Memo to: Vail Townhouse Condominium Board *via FAX*  
From: Ginny Welles  
Date: September 30, 2005  
Re: Changes to Site Wall and Landscape plan

Modified Elevation  
for 6A+6B

Modified Plan  
for 6A + 6B

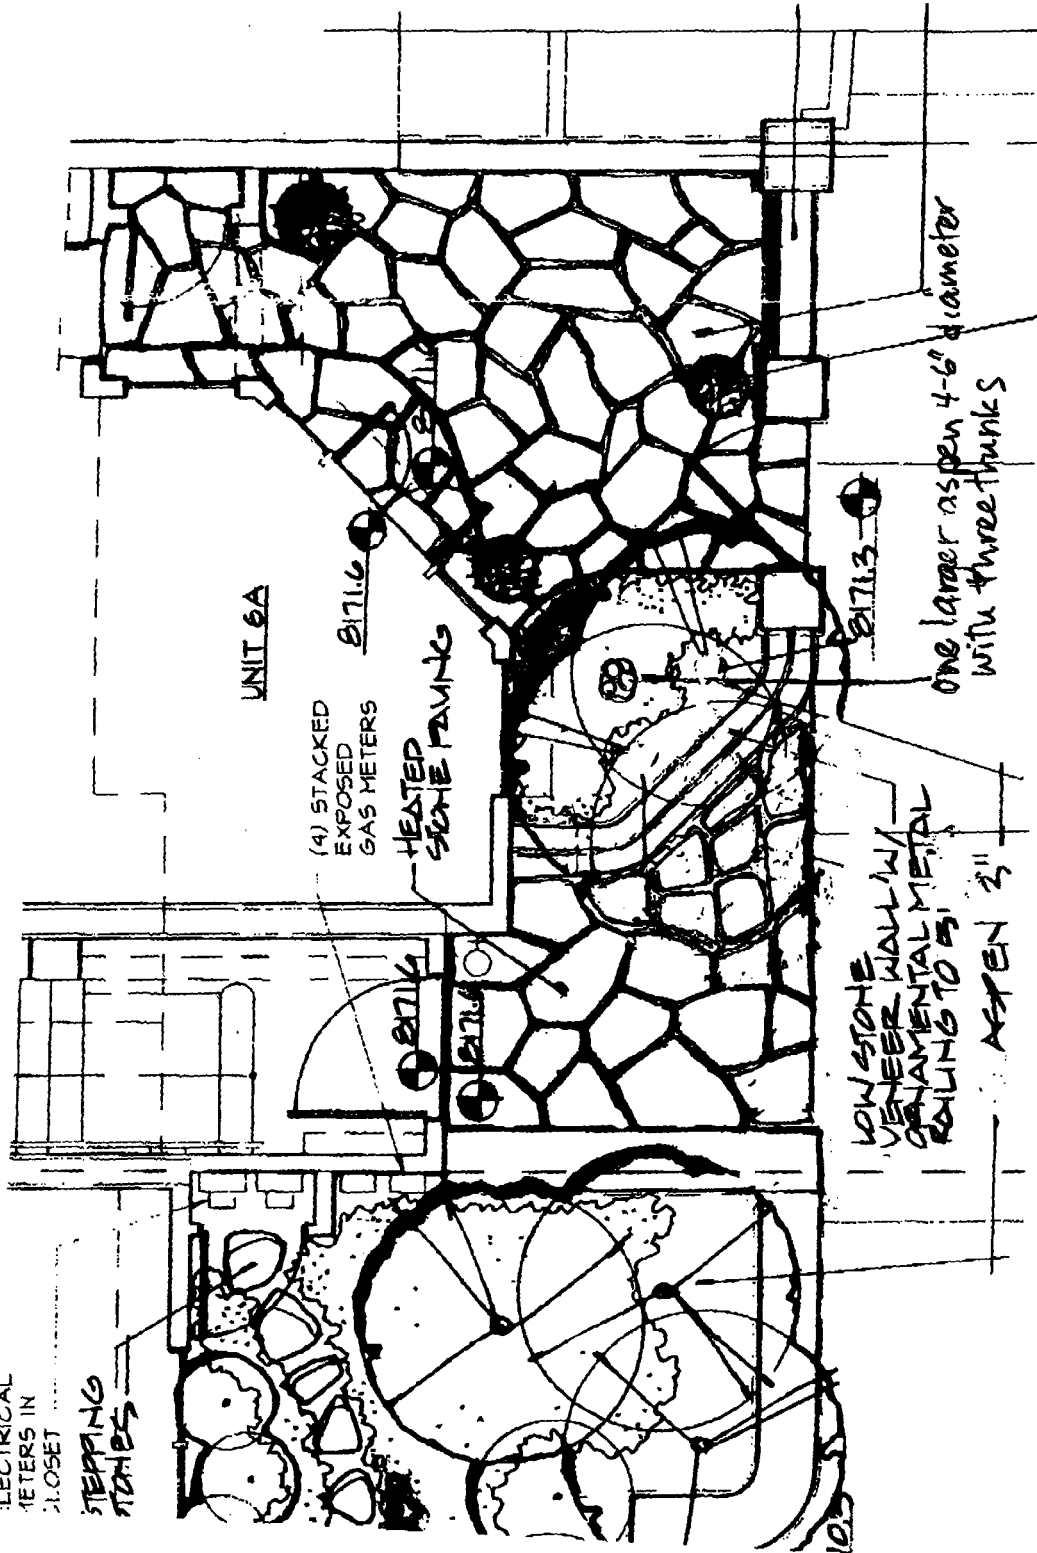
- 1) The columns to the left and right of 6A front door have been eliminated because they just did not fit well on the site. The wall to the left of our door (west, shared with Lot 5), will now step down from approximately 24" to 18" as it turns west to run along Lot 5's southern edge. The stone wall and metal fence to the right of our door will attach directly to the southern wall of Lot 6 (not into a column as shown on the Ronnberg concept drawing).

- 2) Lot 7's half of the party wall at the end of lot 6 is 75" high so the wall inside the Park's patio, which forms the other half of that party wall, will be 75" in height when the stone cap is placed on it.

- 3) Given where the stone wall with metal top was placed and how it had to be built, there was not enough room to have trees on both sides of the wall. Now there will be one aspen with three trunks that will be on the Park's side of the wall. We propose to plant a larger tree there, so that it will provide what the Board is seeking to help soften the massing of the building façade.

one larger aspen 4-6" diameter  
with three trunks
